Number: SB 2X-31-05 R2

SNS SUBJECT: 31-30 RECORDERS - Recoverable Data Module Replacement

Cirrus Design SR22 Serials 3026 thru 3368 w/ Perspective Avionics.

Figure 1
Recoverable Data Module Installation

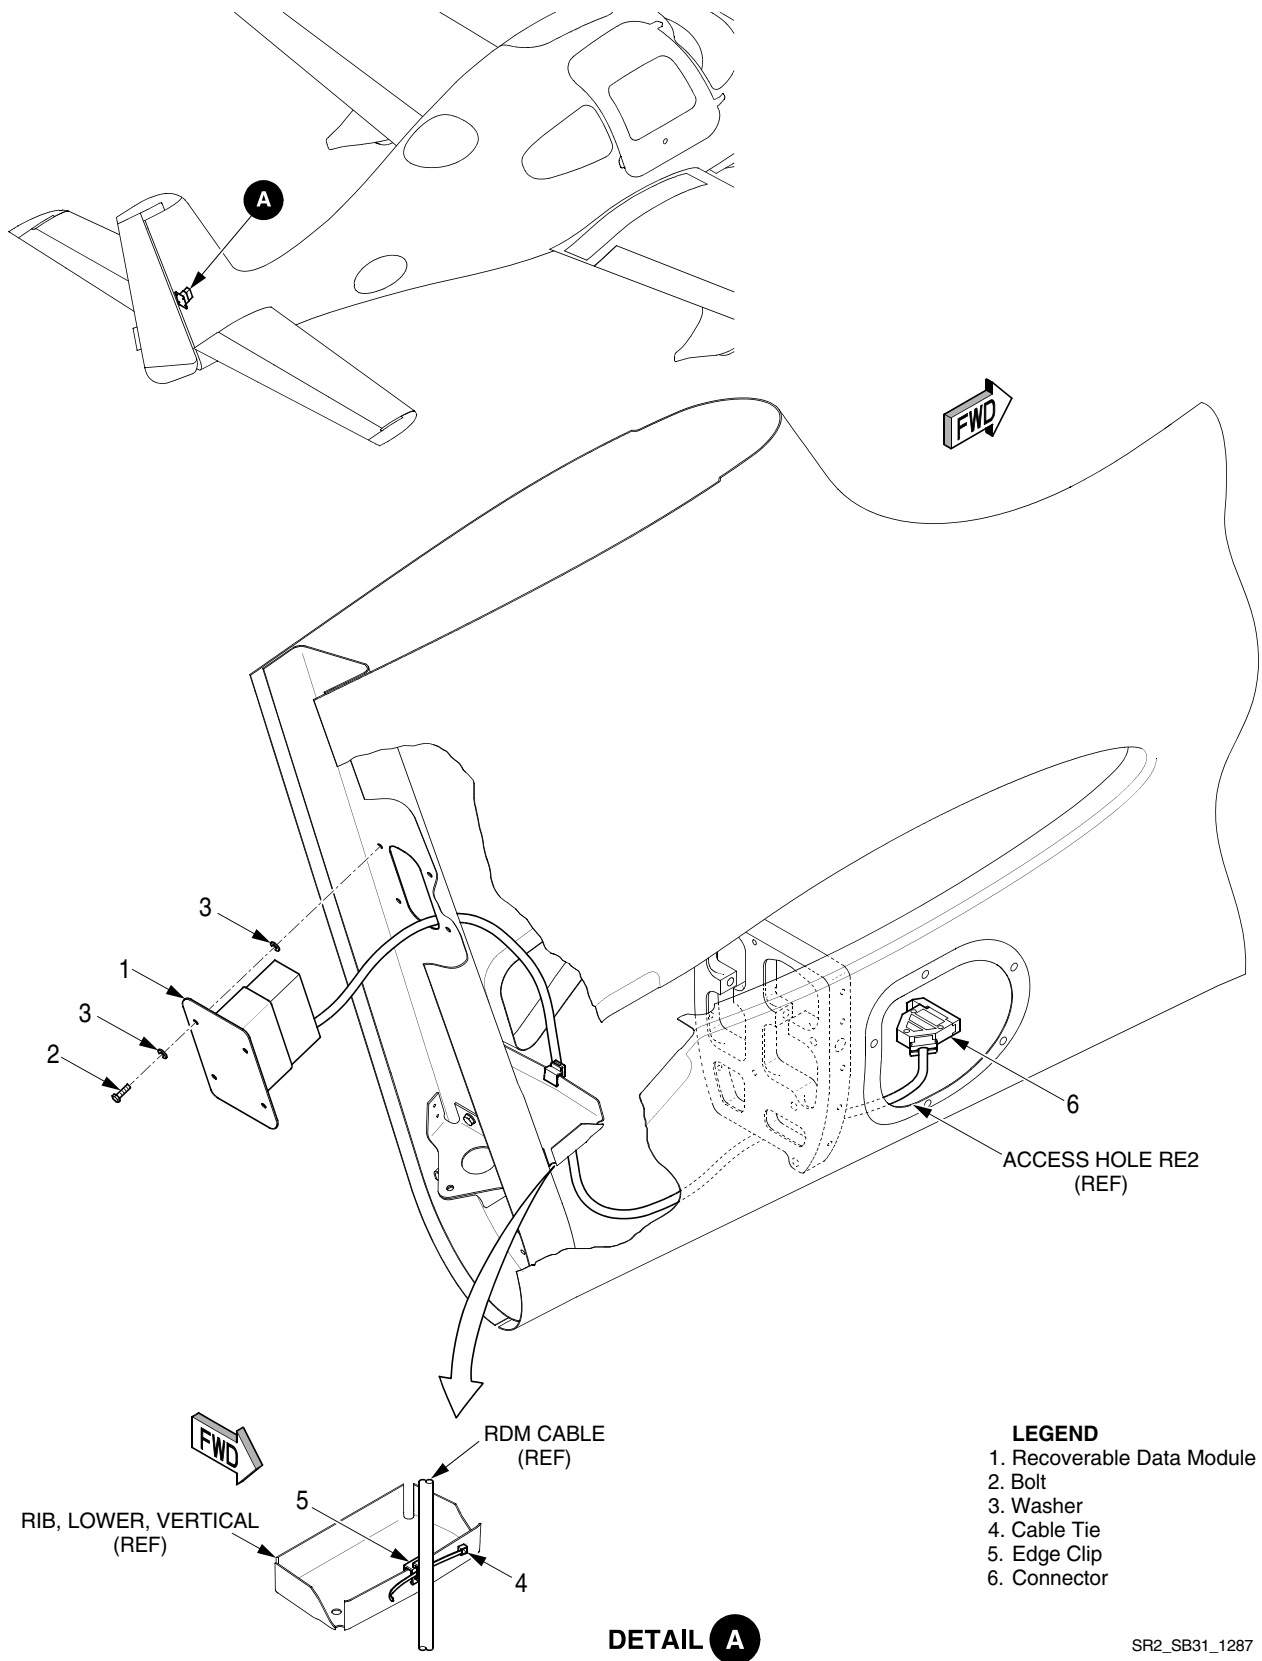
Cirrus Design recently discovered a condition on aircraft with Perspective Avionics where the Aircraft Data Logger (ADL) fails to store data correctly. Upon investigation, it was determined that the condition is caused by the Recoverable Data Module (RDM) internal software. To correct this condition, the affected RDM must be replaced with an RDM with improved software.

- (1) Remove cable ties securing RDM cable to empennage.
- (2) Disconnect RDM connector from wire harness.
- (3) Remove screws and washers securing RDM to empennage. Remove RDM from airplane.
- H. Package removed RDM and ship to Heads Up Technologies to receive a replacement RDM.
- I. Install replacement RDM.
 - (1) Position RDM to empennage and secure with screws and washers.
 - (2) Connect RDM connector to wire harness.

WARNING: Verify no interference exists between RDM cable and flight controls.

- (3) Install cable ties securing RDM cable to empennage.
- (4) If disconnected during removal, connect pitch trim cartridge to aft empennage bellcrank. (Refer to AMM 27-30)
- J. Reset FUEL QTY, GPS NAV GIA 1, and STALL WARNING circuit breakers.
- K. Perform Operational Test - Aircraft Data Logger System.
 - (1) Set BAT 1 switch to ON position.
 - (2) Open center armrest console and remove glove box trim to access diagnostic LED. (Refer to AMM 25-10)
